PROJECT: **Venice Volleyball Facility**
Application for Site Plan Administrative – DFT
Response to Staff Comments
PR-2019-001959
SI-2024-00040

Property Location: 5801 Venice Ave. NE
Albuquerque, New Mexico 87113

Below are the comments in orange that our office received for the DFT Application No.: SI-2024-00040 for Project: PR-2019-001959. Our response and/or clarification to these comments are immediately below in black, and are indicated as necessary in the revised drawings attached to this response.

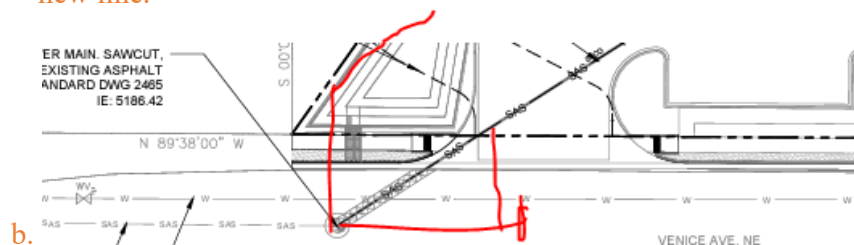
1. Availability Statement 231005 provides conditions for service. The Statement includes a requirement to extend a public sanitary sewer line. However, if the site can access the sanitary sewer service without the extension and show that is the case, this can be discussed further.

- a. Currently the site plan shows a connection that is not perpendicular to right-of-way or the existing sanitary sewer line. As noted, the provided requirements are to extend infrastructure which will provide a perpendicular connection and not what has been proposed on this site plan. Shown below are two potential options; 1 (left) is to come perpendicular into the manhole and make bends within the property but a pond appears to be in conflict, 2 (right) extend per the Availability Statement and take service from the new line.

The Site Utility Plan has been revised to follow Option 1, indicated above. A reduced ponding requirement has allowed for ponding in that area be revised and allow for this sanitary sewer location and path without any conflict with the ponding area. This is shown in the Revised Site Utility Plan included in this response.

SITE PLAN
ADMINISTRATIVE DFT -
SITE DETAILS / BUILDING
ELEVATIONS

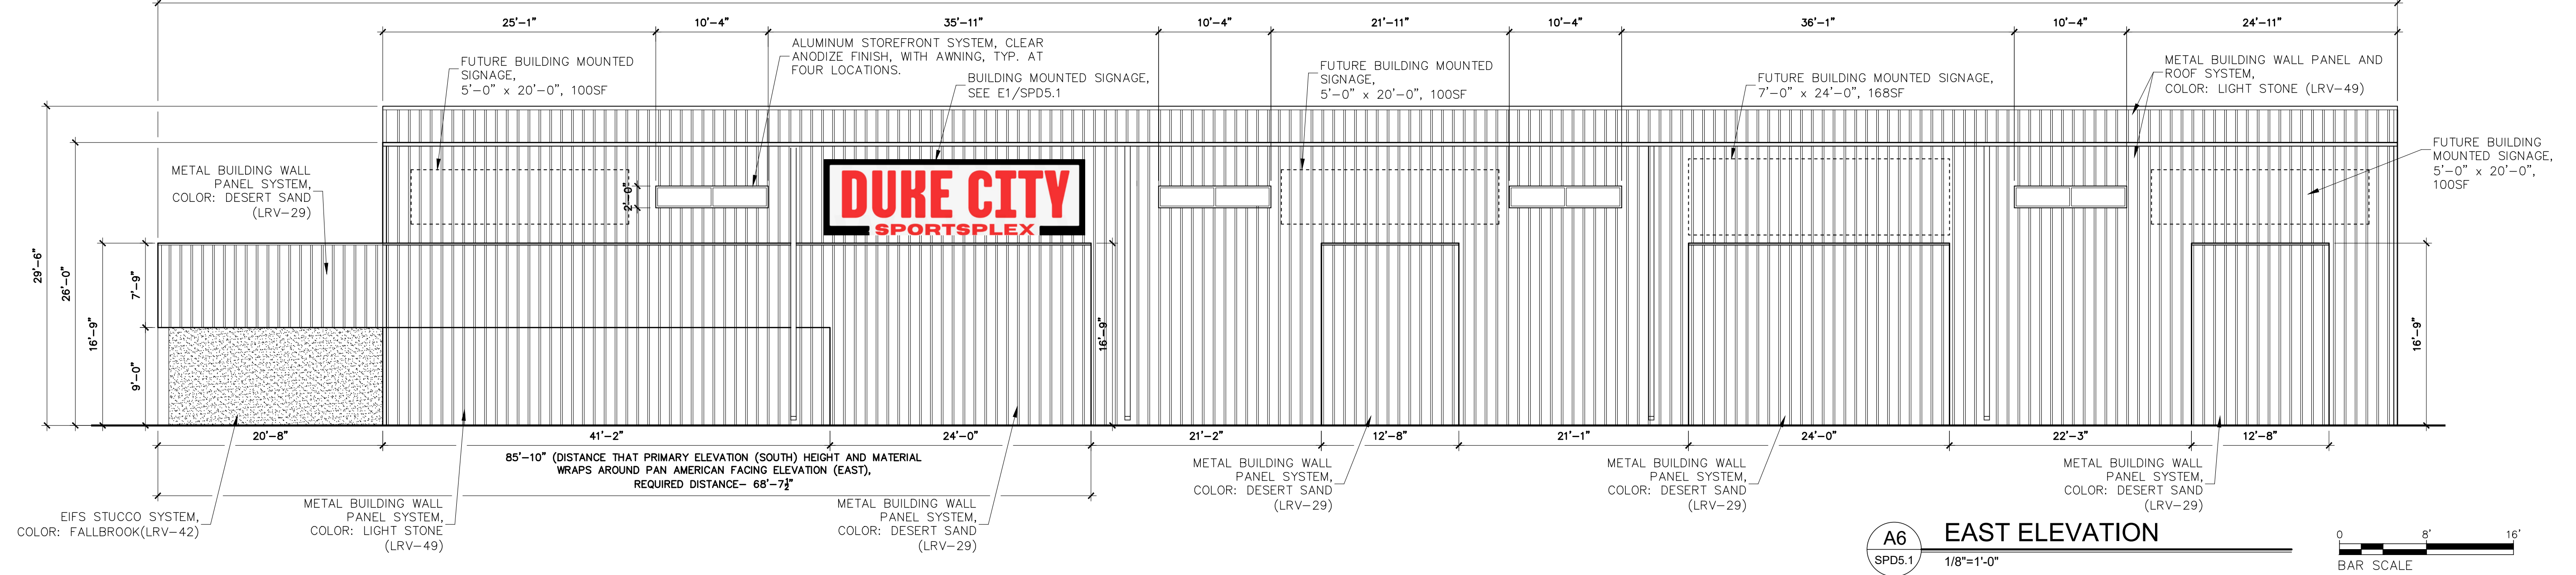
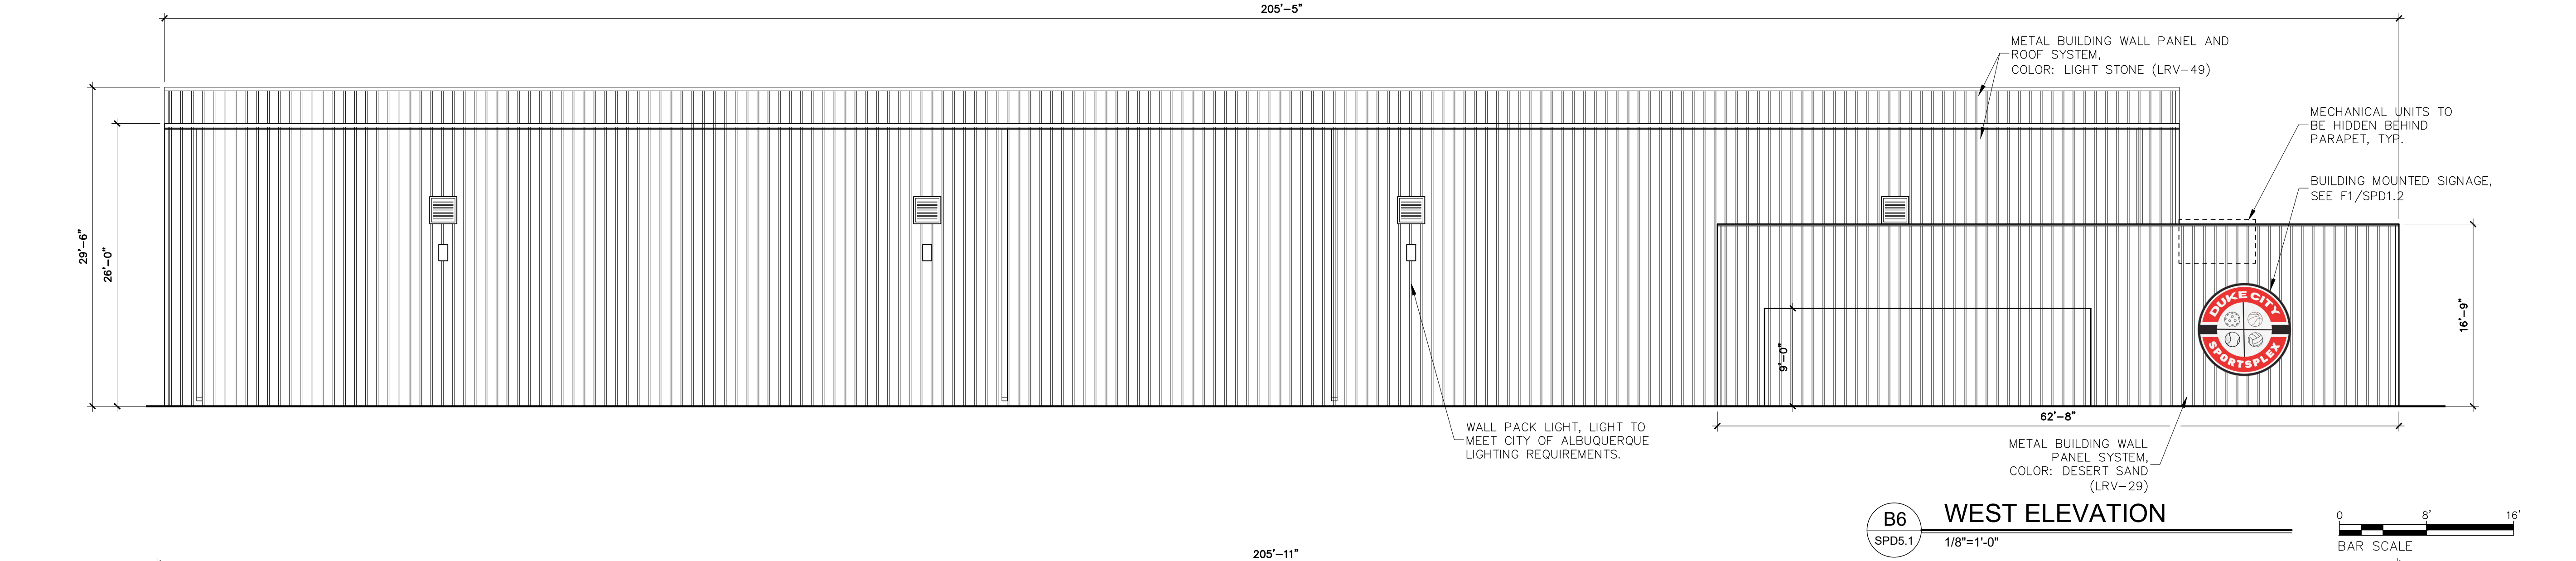
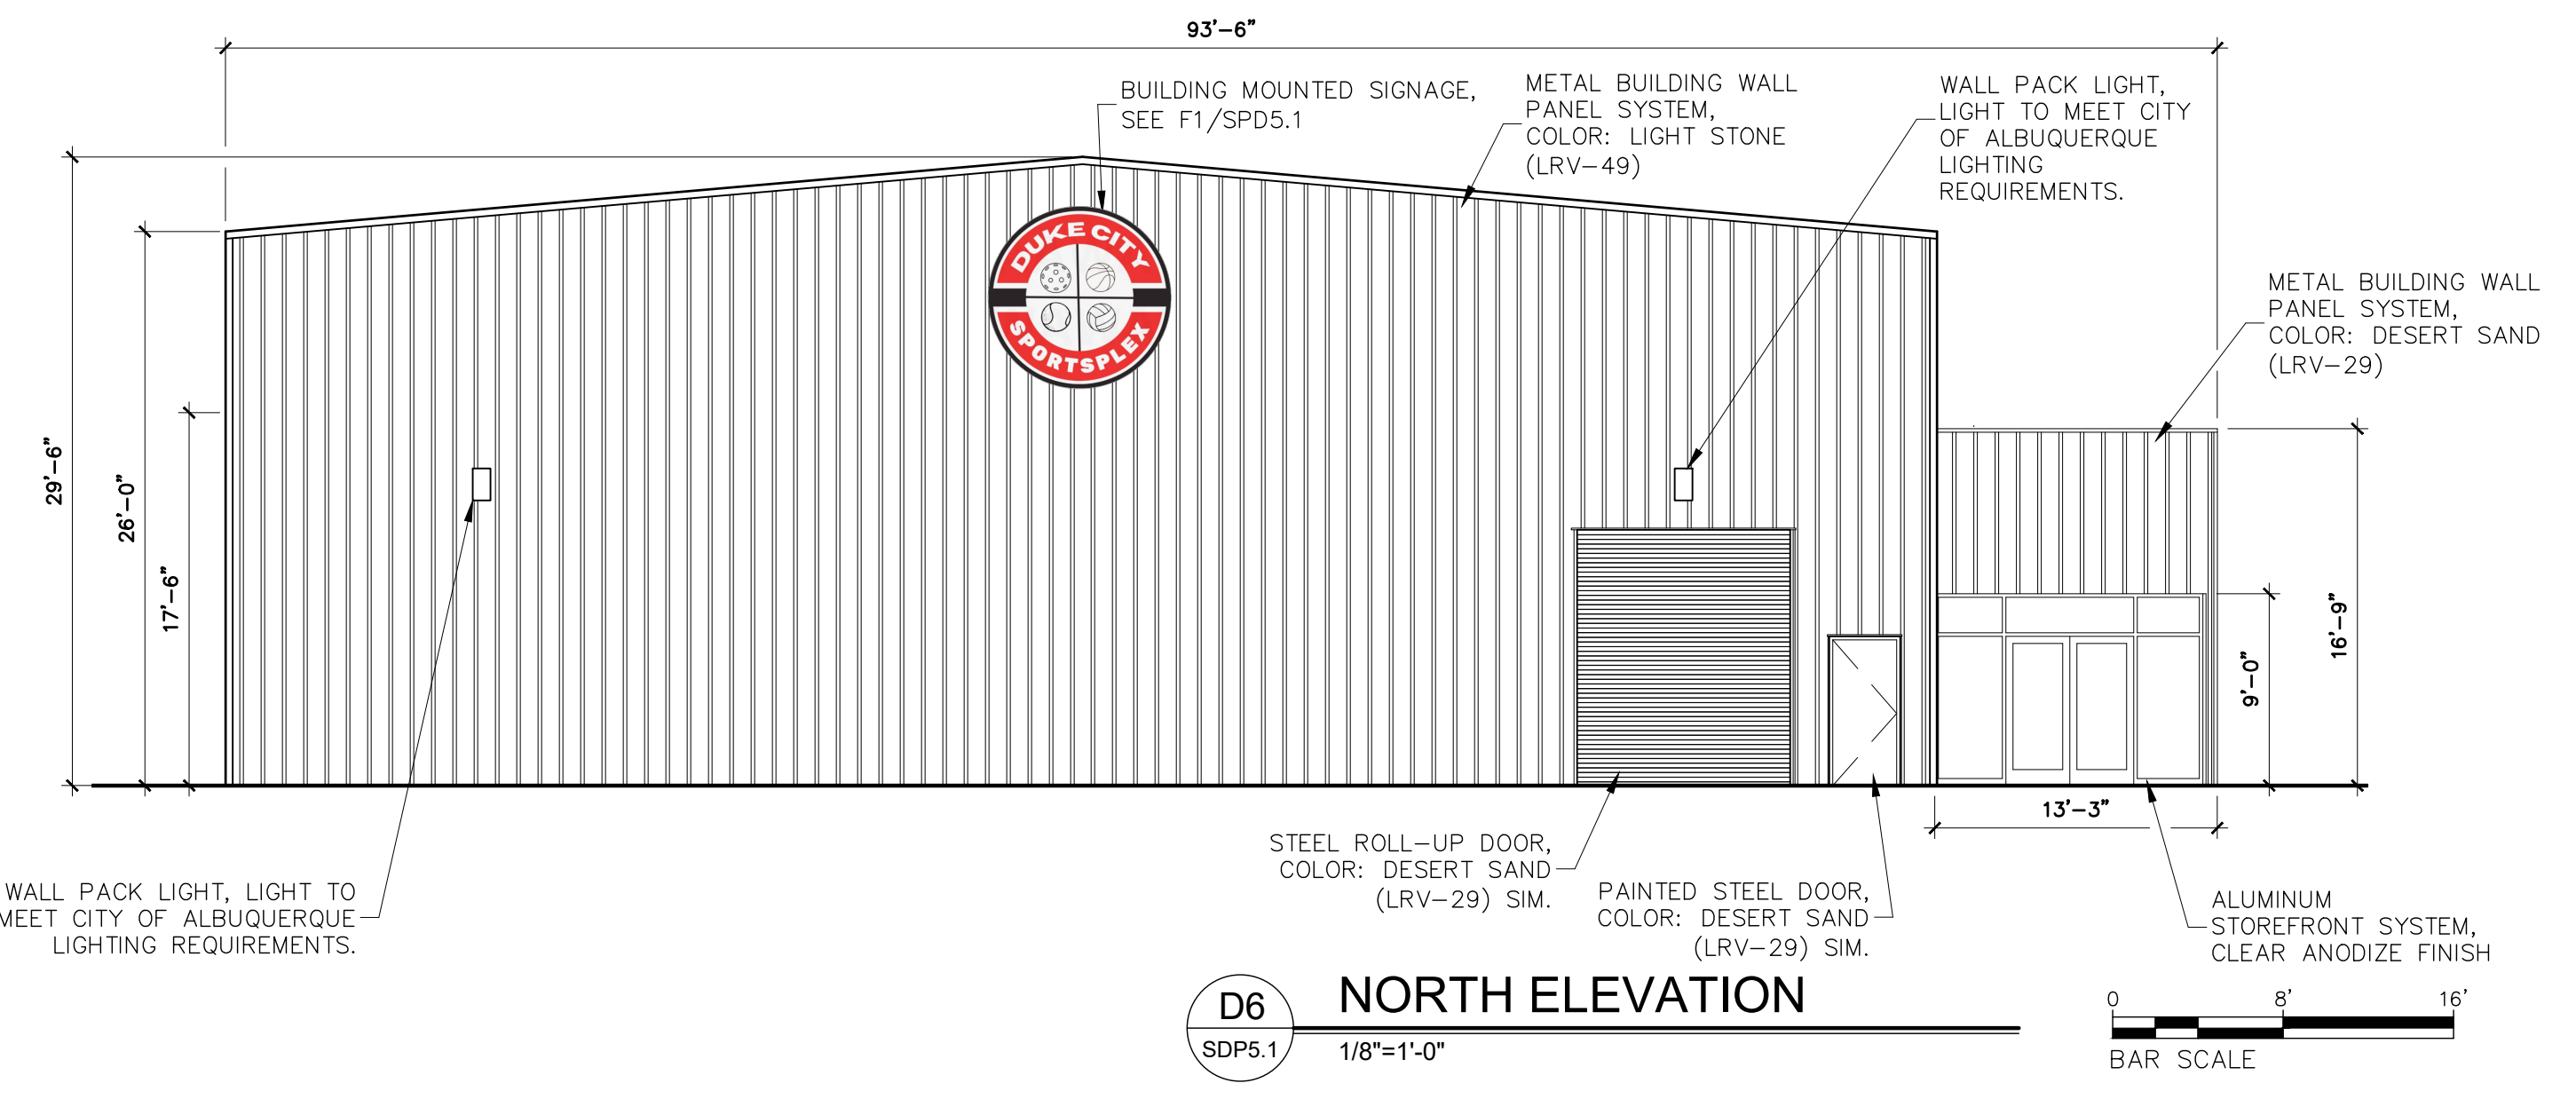
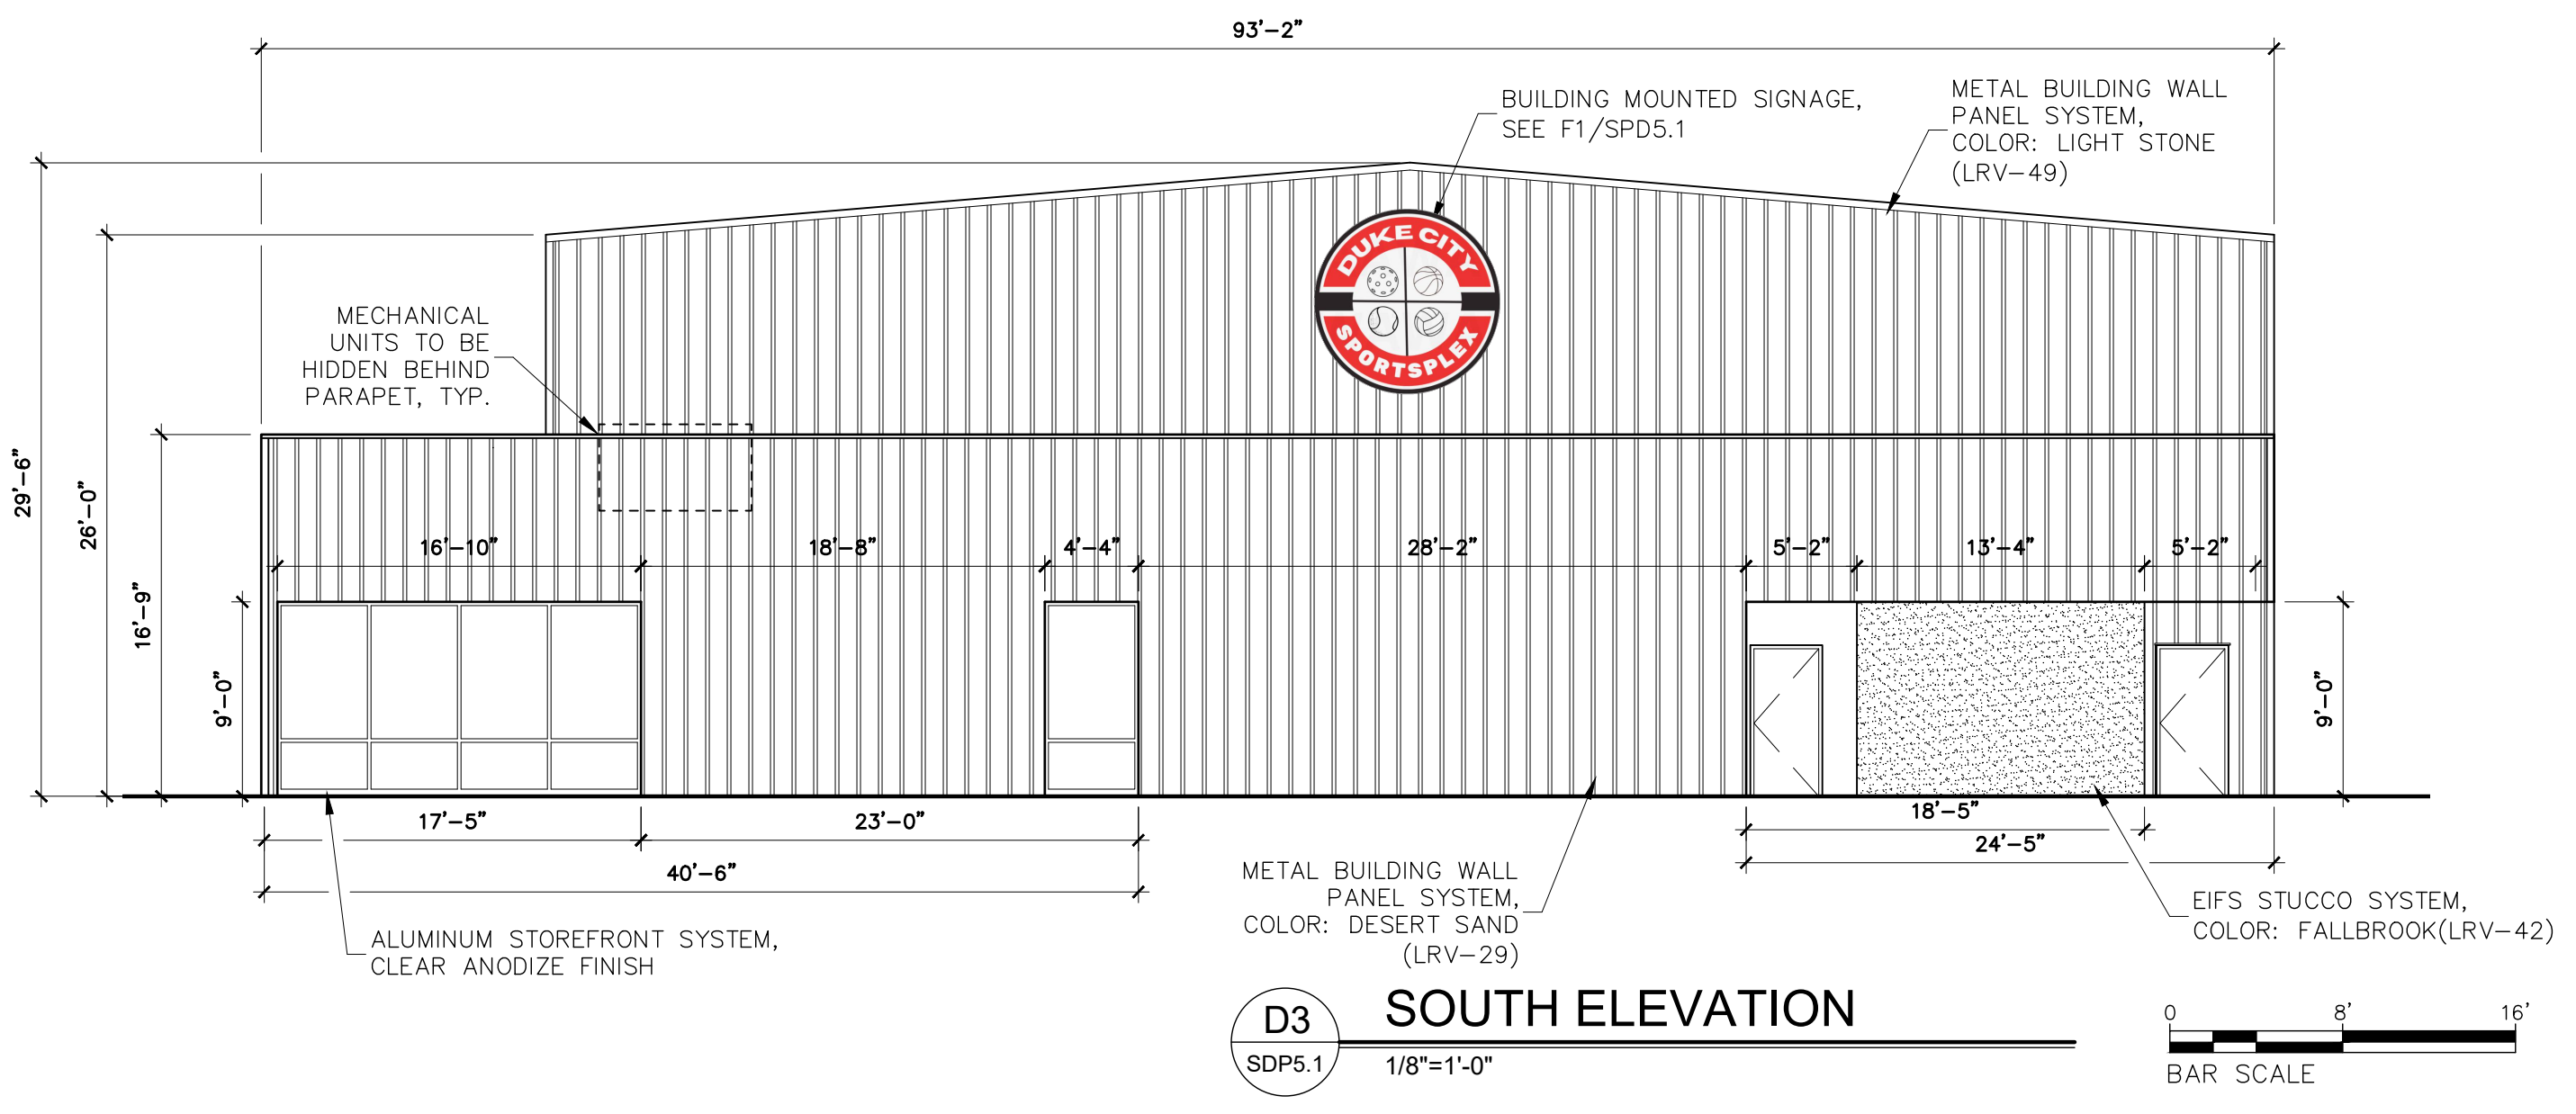
- Because the property is within CPO-10, facades do not appear to be meeting requirements for Building Design. Provide additional detail within the elevation pages and a comment response memo that demonstrates how façade design is meeting the requirements of 3-4-K-4-b and 5-11-E.

4. Show how you are meeting the CPO-10 Building Design façade requirements as per IDO 3-4(K)(4)(b) and IDO 5-11(E), as referred and required in CPO-10 for a property in the NR-LM zone. See excerpt below.

The Eastern Façade has been revised to have a continuous band of color, material and elevation wrap from the primary South elevation facing Venice to the East elevation facing Pan American. This Elevation has been reviewed and approved by Jeff Palmer with Code Enforcement. Please see revised SDP5.1.

The Eastern Façade has been revised to have a continuous band of color, material and elevation wrap from the primary South elevation facing Venice to the East elevation facing Pan American. This Elevation has been reviewed and approved by Jeff Palmer with Code Enforcement. Please see revised SDP5.1.
